XT30 and XT50 Cellular Series

Hardware Update

TU-0533 © 2009 Digital Monitoring Products

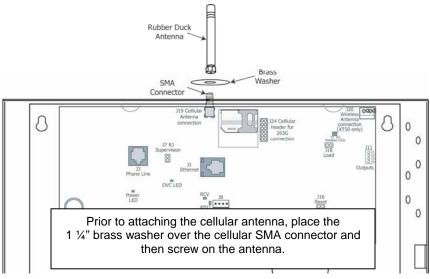
Some dealers have reported when using the rubber duck antenna, certain sirens make a chirping sound during cellular communication and in some cases zone 10 would trip. By placing a 1¼" brass washer over the antenna connector on top of the panel both issues are corrected.

As of August 24, 2009, the XT Series cellular panels will now include the $1\frac{1}{4}$ " brass washer to be used during the installation of the cellular antenna.
